**Bulletin**

MODEL: BENTLEY MARK VI

CLUTCH PEDAL.

CLUTCH SLIP.For Information:

Fig.1. Section through flywheel and clutch.

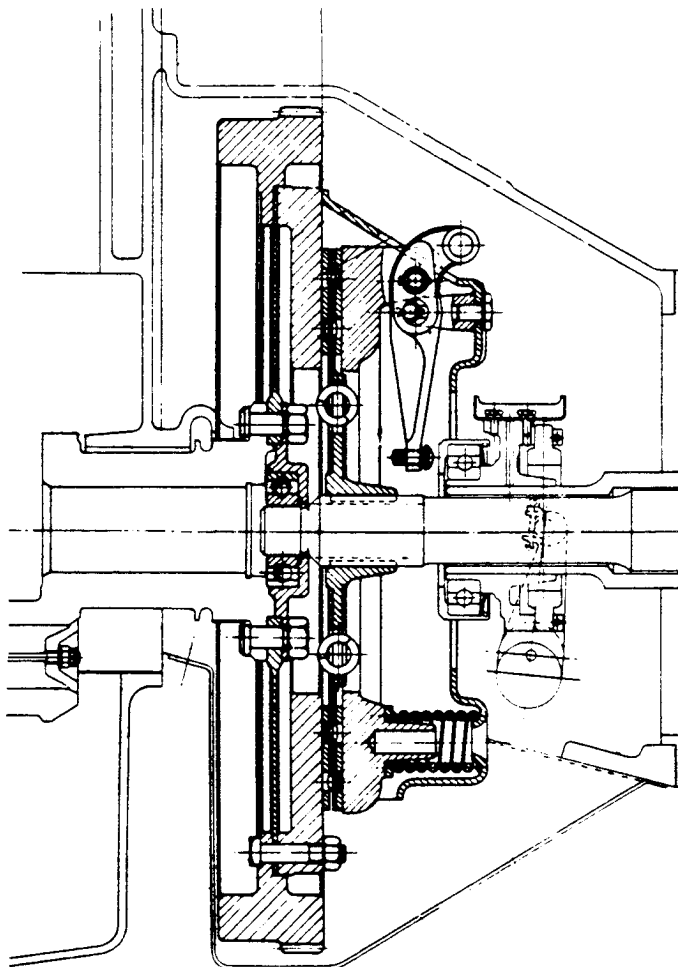
The information contained in this Bulletin is issued for guidance in the event of complaint being received of a slipping clutch, the principal causes of which are:-

- A. Insufficient free travel of the clutch pedal preventing full engagement of the clutch.
- B. Oil or grease on the friction surfaces of the driven plate assembly.

Before resorting to any dismantling for slip, the free travel of the clutch pedal should be measured and adjusted if necessary as follows:-

With the clutch pedal lever against its up-stop under the pedal gap plate, place the edge of a rule against the centre of the side of the pedal and the end of it against the dash, depress the pedal by hand until the clutch release bearing just touches the three release levers of the clutch. Measure the free travel which should be  $1\frac{1}{2}$ " (38 m/m). A turnbuckle adjuster with a central spanning point is provided. Insufficient free travel of the clutch pedal can be one of the causes of clutch slip. If clutch slip is experienced at high engine R.P.M., it indicates that there is insufficient pedal clearance.

Fig.2. Section through flywheel.

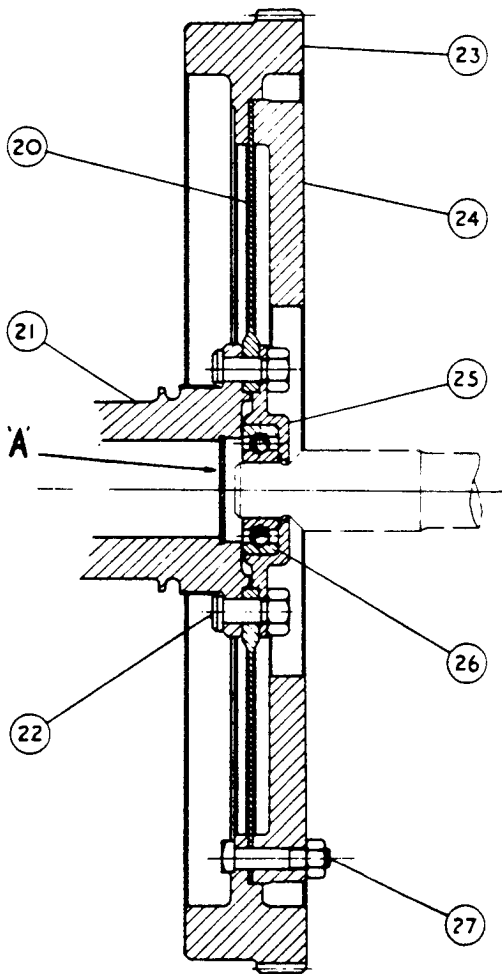
1. Oil leakage past the sealing washer 'A' Fig.2 at the rear end of the crankshaft.
2. Excessive initial loading of grease into the clutch spigot ball bearing (26 Fig.2) of the flywheel, distinguished by radial grease marks on the friction plate (24).
3. Over zealous application of the foot-operated chassis oil pump or a faulty oil restrictor (Type ZEO), allowing too much oil to reach the clutch release bearing (32 Fig.5) eventually working its way along the splines on to the driven plate.

It has been found on investigation, that under certain conditions there is a possibility of an oil leakage past the sealing washer ('A' Fig.2) at the rear end of the crankshaft. If the leakage is sufficient, oil may reach the front facing of the driven plate. In practice, it is likely that the first indication will be a clutch shudder and then a slipping clutch. If after removal of the clutch, oil, apart from grease, is found to be present in the spigot bearing (26 Fig.2), it can be assumed that it is leaking past the sealing washer.

Whenever there is evidence of oil leakage past the sealing washer, a rubber plug should be fitted as described herein. If however, a rubber plug is not immediately available, then it will be necessary to solder the sealing washer ('A' Fig.2) to the crankshaft as described in Paragraph 1b.

With the clutch removed from the flywheel, remove the crankcase lower half. Remove the nuts from the twelve bolts (22 Fig.2). Providing the nuts have not been over centre punched, it should be possible to use them again. Leaving the flywheel assembly in position on the crankshaft, remove the bearing housing (25) complete with the spigot bearing (26). Remove any surplus oil or grease from the spigot bearing and housing and do not add any additional oil or grease.

Thoroughly clean the bore of No.7 crankshaft journal by syringing it out with petrol and then wipe out with a clean cloth, also clean around the outer periphery of the sealing washer. As the crankshaft is nitride hardened, it is therefore difficult to solder unless very carefully cleaned. When soldering, use a good quality soldering flux i.e. not spirits of salts.

Taking the necessary precautions, apply heat to the washer by means of a small blow lamp or gas flame sufficiently to warm up the washer for soldering purposes. An oxy-acetylene flame must not be used for this purpose, as the heat is too intense and too localised.

Trim up as necessary the ends of the twelve flywheel bolts, providing a suitable die is available, i.e. .375" dia. 20 T.P.I., (R.H.) B.S.F. Clean up the first two or three threads only. It may be necessary to hold the die itself by hand, owing to the limited space between each bolt. Care must be taken when refitting the nuts not to damage the bolts, otherwise it will be necessary to remove No.7 main bearing cap in order to remove the damaged bolt and fit a new one.

Place the housing in position. It should be noted that one of the bolt holes in the housing is off-set for co-relation purposes. Providing the nuts have not been damaged, they can be cleaned up with a suitable tap. Should new nuts be required, the Part No. is K-4010. After thoroughly tightening up the nuts, re-centre punch each bolt in four places to lock the nut.

Fig.3. Details of oil sealing plug.

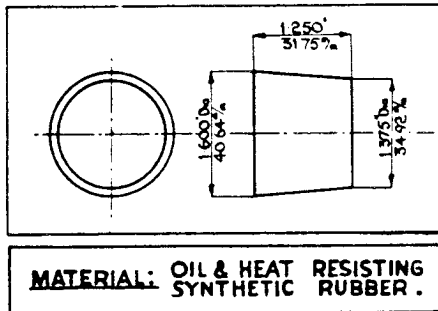
As a service rectification, a conical synthetic rubber oil sealing plug (Fig.3) has been introduced and is shown in position in the bore of No.7 crankshaft journal in Fig.4. Arrangements are being made for supplies of these plugs to be sent to all Overseas Retailers. Will Retailers in the U.K. kindly note that supplies are available from the London Service Depot.

**MATERIAL: OIL & HEAT RESISTING SYNTHETIC RUBBER.**

With the clutch removed from the flywheel, remove the crankcase lower half, taking care to try and avoid damaging the Vellumoid joint fitted between the face of the crankcase and the wheelcase. Before fitting the rubber plug, it will be necessary to drill a 1/16" dia. (1.5mm) air escape hole in the centre of the existing sealing washer. Prior to drilling, and to prevent any drilling swarf from dropping into the spigot bearing (26 Fig.2), cut a piece of paper about 1 1/2" (38mm) wide, grease it on one side and then fold it in cylindrical form so that the greased side is on the interior, pass it through the spigot bearing and up to the face of the sealing washer. After drilling the washer, remove

burrs from hole and then carefully remove the paper tube, together with all traces of swarf which will be found to be trapped on the greased side of the paper.

Fig.5. Section through clutch release bearing and trunnion.

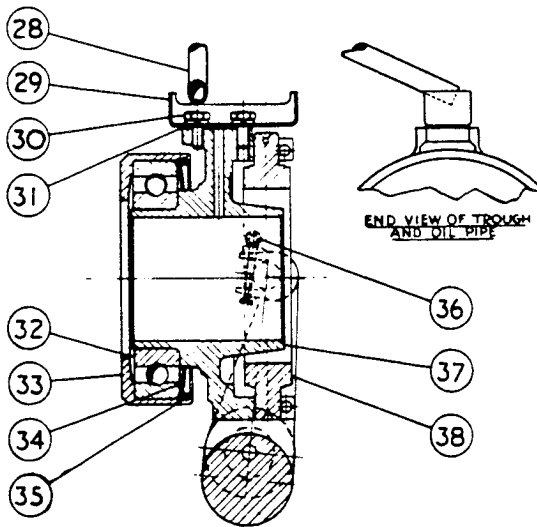
The above will probably allow too much oil to reach the clutch release bearing (32 Fig.5) and eventually find its way on the rear facing of the driven plate assembly. The chassis oil pump should only be operated in accordance with the instructions given in the Owners Handbook i.e. "Depress

If the clutch has been removed for the purpose of fitting a new driven plate assembly, then prior to refitting the gearbox to the clutch casing, ascertain that the oil feed pipe (28 Fig.5) to the oil trough of the clutch trunnion is correctly positioned above the trough. The end of the pipe should be approximately over the front setscrew (i.e. the one nearer to the flywheel) retaining the trough to the trunnion when the clutch release bearing housing (33) is in contact with the adjusting screws of the three clutch release levers. Check that the oil feed hole from trough to the trunnion is clear. With sufficient oil in the foot-operated oil pump, depress the pedal once and count the number of oil drops delivered to the trough of the trunnion.

Approximately three to five drops should be delivered with each application of the pedal. If either above or below this rate of flow, check the restrictor elbow situated on the right-hand top side of the clutch casing, by replacing with a new one of the same type (ZE0).

If the flow is still too great, then fit a type ZE00 elbow which will give a reduced rate of flow, conversely if there is still insufficient oil delivered, then check for a leakage or pipe breakage at some other point in the centralised chassis lubrication system.

FIG.1 FLYWHEEL AND PRESSURE PLATE - ORIGINAL DIMENSIONS.

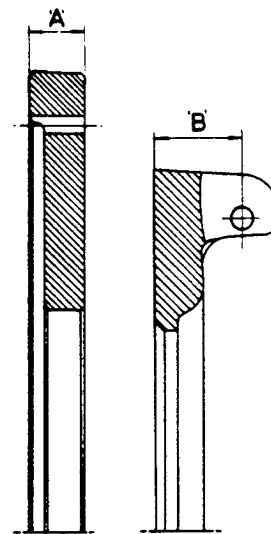
It is permissible to regrind the surface of both the flywheel friction plate and the clutch pressure plate should they show signs of scoring. Only the minimum amount of metal necessary to provide a clean, smooth surface should be removed. Grinding limits and original dimensions are given in Fig.1.

Flywheel Friction Plate

Dimension 'A' .800" (20.32 m/m)  
Grinding Limit .050" ( 1.27 m/m)

Clutch Pressure Plate

Dimension 'B'  
10" Clutch 1.284" (32.61 m/m)  
11" Clutch 1.286" (32.66 m/m)  
(Light and Heavy)  
Grinding Limit .030" ( .76 m/m)

A surface grinder should be used and a Carborundum stone of grade BA80-N5-VBLU is recommended. The clutch pressure plate may be placed face downwards on the machine table and the backs of the lugs for the toggle levers lightly ground flat to provide a true surface. The plate may then be reversed and the face ground as required.

A flywheel friction plate that shows any sign of small, hair-line, contraction cracks should be discarded.
